WG: C37.010 - Circuit breaker application Guide

Chair: Helmut Heiermeier

Location: San Diego

CB application guide C 37.010

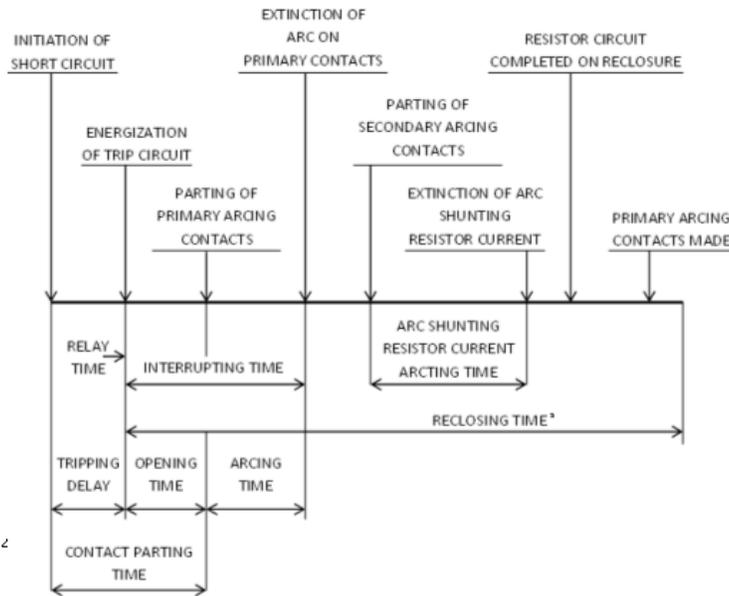
In case a circuit breaker has a bigger spread in mechanical closing time between its phases (either by intention or by its inherent behavior) a higher peak current when making a short circuit may occur. In such a case other devices in the substation may be overstressed with regard to the maximum short circuit peak and the next higher current rating for these devices may be necessary.

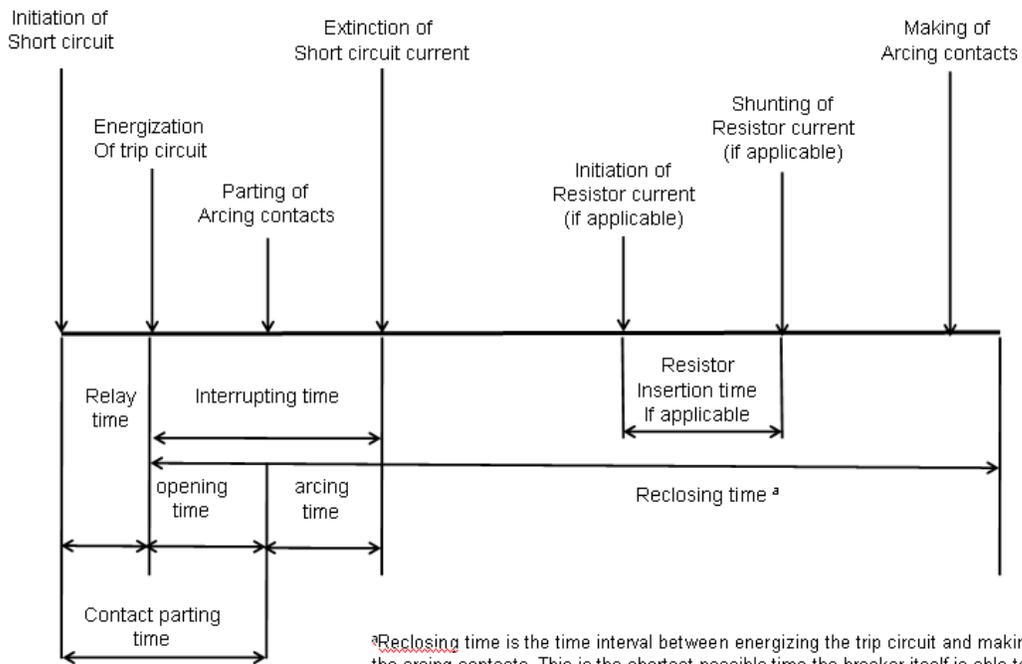
9.) The chair reviewed suggested changes to Figure #2 – operating time graph in C37.010. He added additional information for closing resistor applications. Several comments were made and most seemed to like the new graph. The information will be added to the document for ballot.

Is this figure correct? Do we need to consider resistor application?
